# Falcon Fire Station No. 3 Grading & Erosion Control Plans El Paso County, Colorado

FALCON FIRE STATION NO. 3

**SITE GRADING & EROSION CONTROL PLAN**

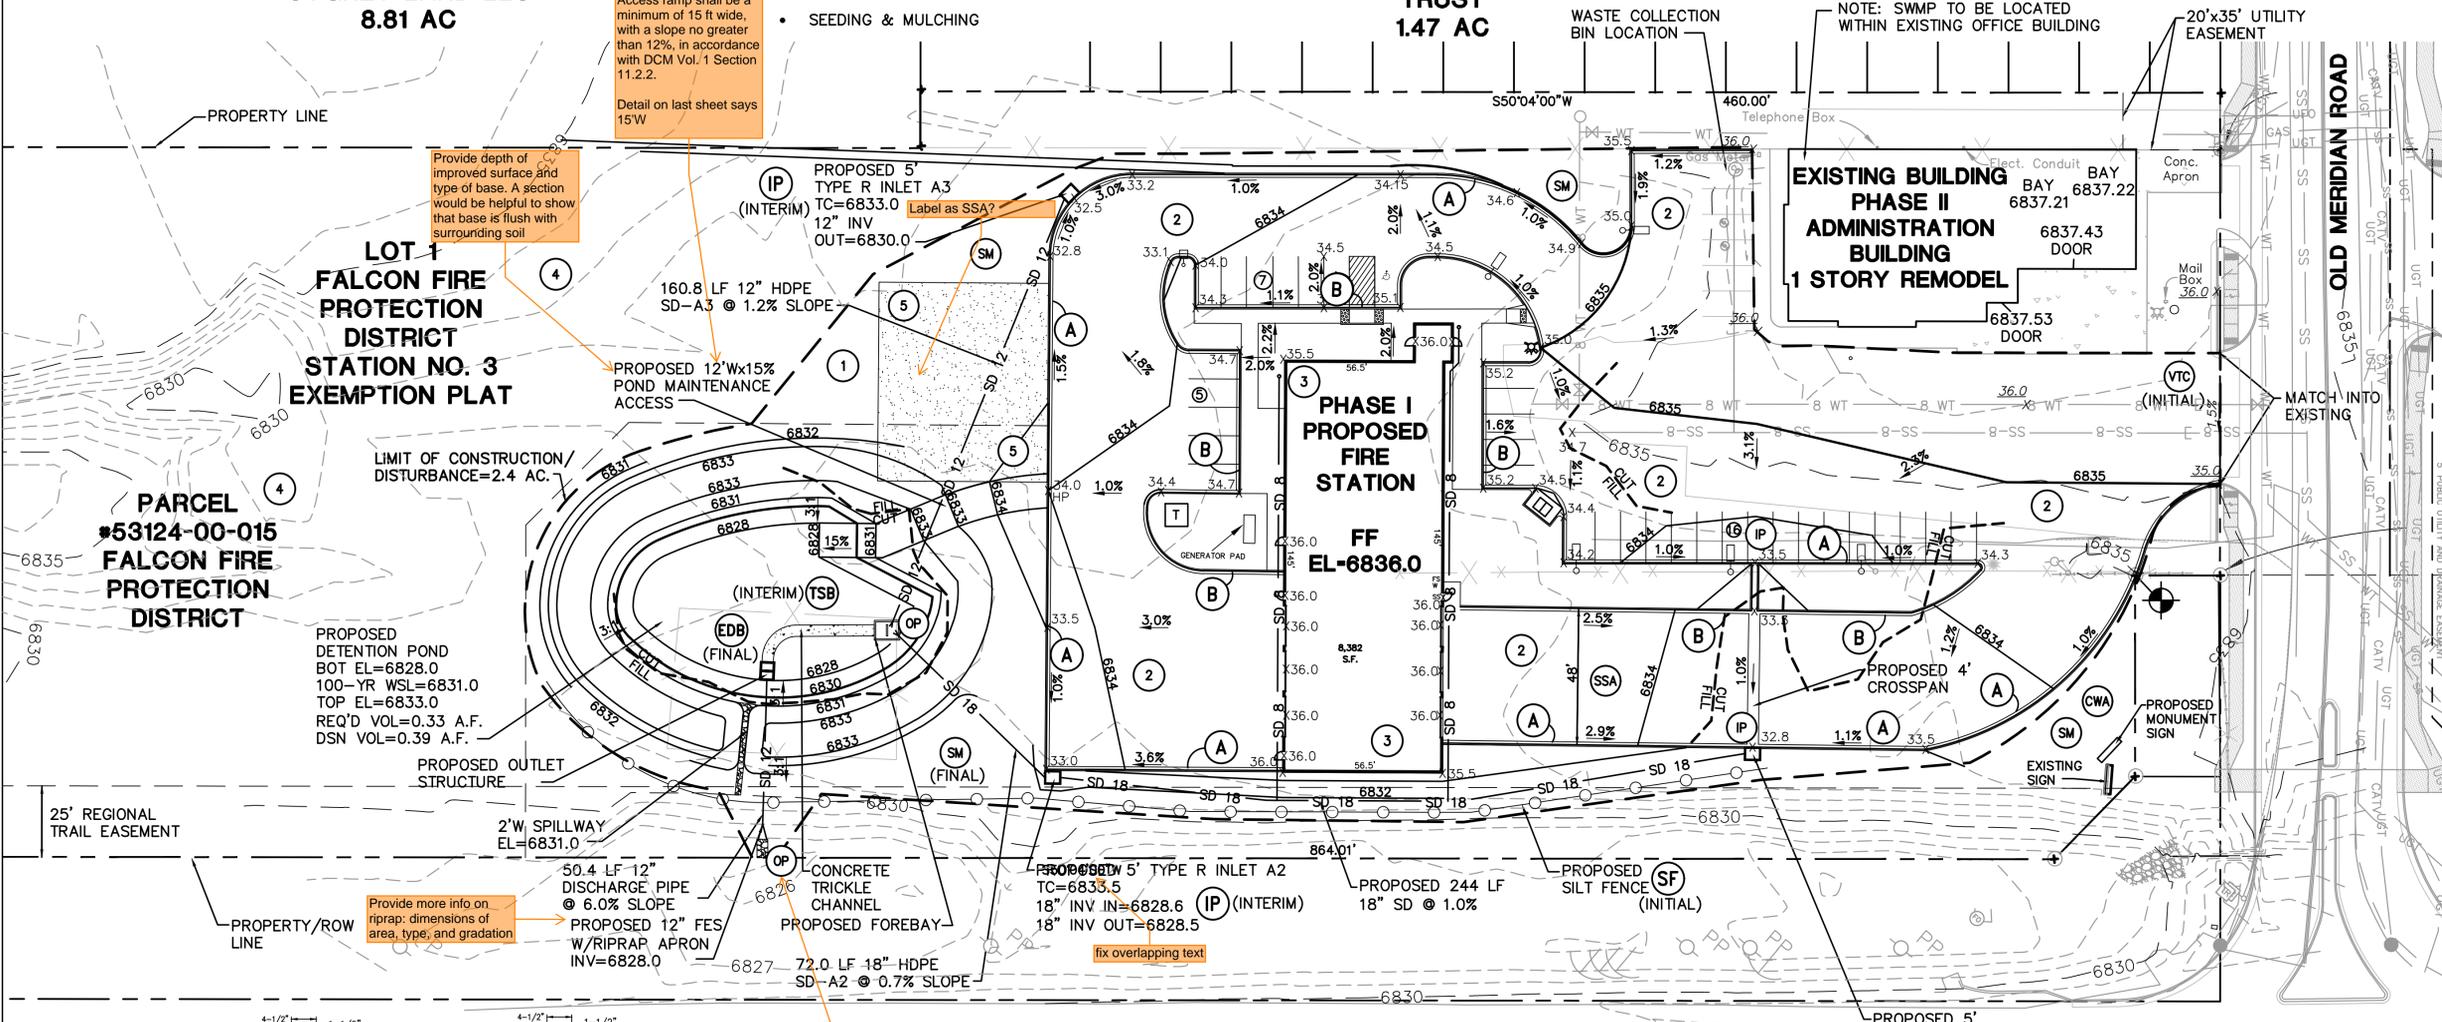
Specify what the temp OP will be. Is the FES to act as temp and permanent OP? Either way, MHFD detail EC-8 may be appropriate to include with plans

DETENTION POND A PLAN

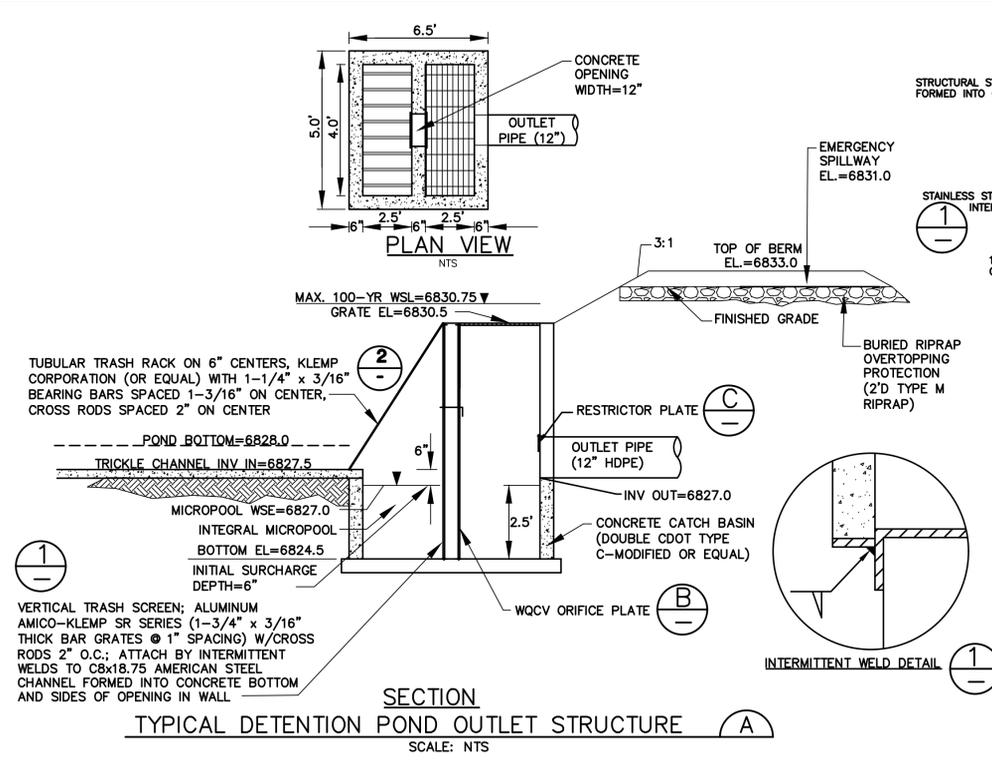
Plan drawing on sheet C1 still says 12W. Revise so they are not contradicting.
